SUBJECT: EXEMPTION AMENDMENT FROM CERTAIN TECHNICAL REQUIREMENTS OF APPENDIX R TO 10 CFR PART 50 - NORTH ANNA POWER STATION, UNITS NO. 1 AND NO. 2 (NA-1&2) (TAC NOS. M89192 AND M89193)

ADDENDUM TO EXEMPTION REQUEST # 1
APPENDIX R REPORT
NORTH ANNA POWER STATION

SAFETY EVALUATION BY THE OFFICE OF NUCLEAR REACTOR REGULATION
LICENSEE REQUEST FOR ADDENDUM TO EXEMPTION FROM
CERTAIN REQUIREMENTS OF APPENDIX R TO 10 CFR PART 50
NORTH ANNA POWER STATION UNITS 1 AND 2
DOCKET NOS. 50-338 AND 50-339

FIGURE NO.
 1.3

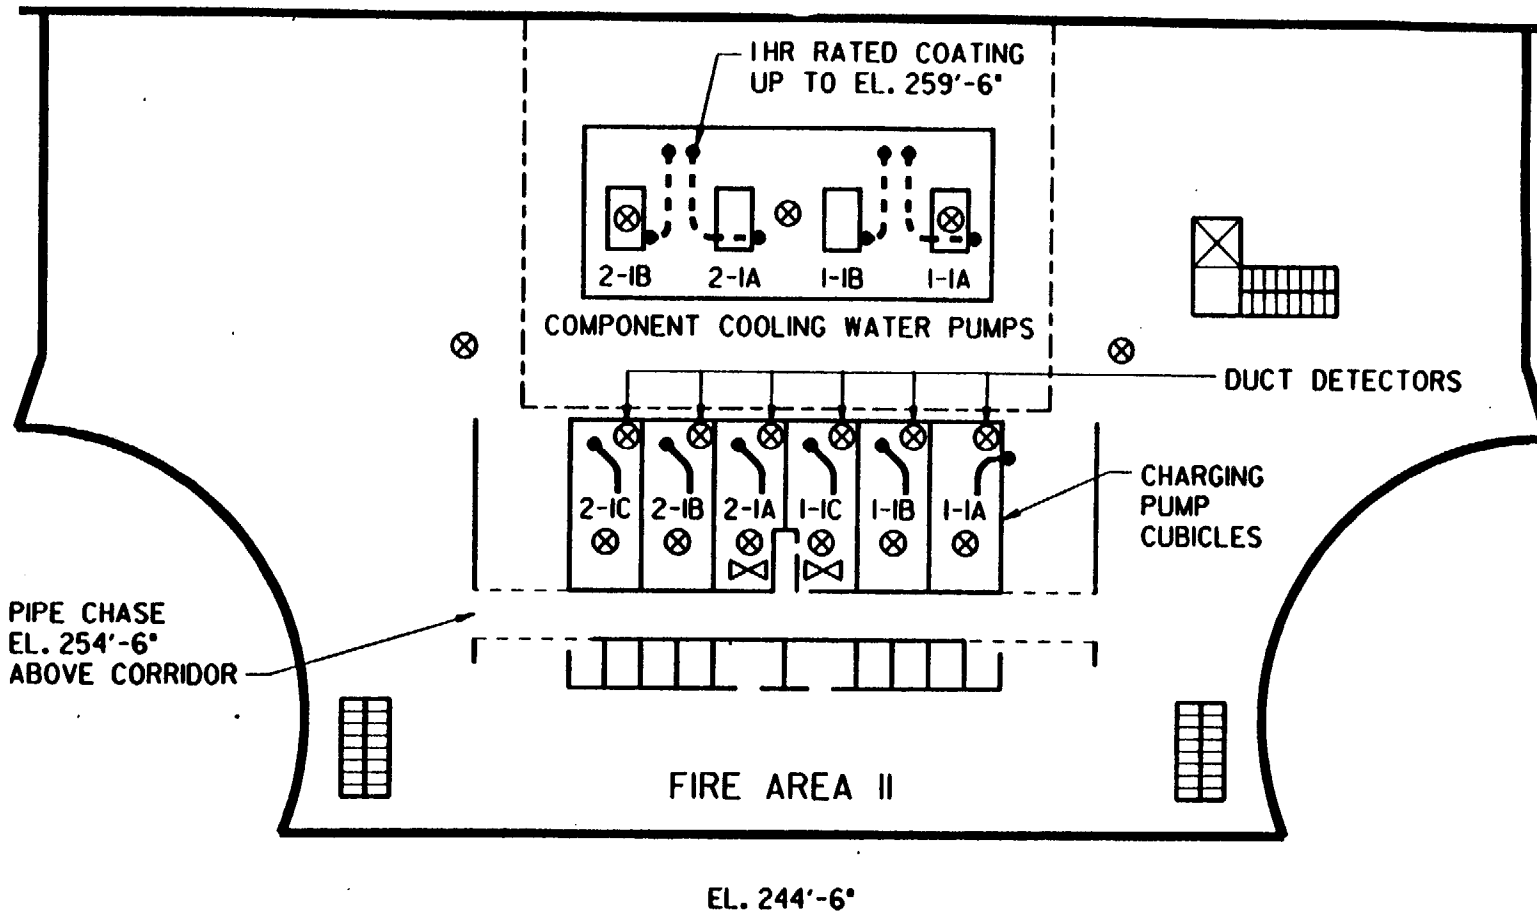
"The horizontal pipe chase is located south of the charging pump cubicles and extends along the south wall of each pump cubicle (See Figure 1.3). The pipe chase is open ended at the pipe penetration areas adjacent to the

2. Figure 1-3 is replaced with the revised Figure 1-3 (attached).
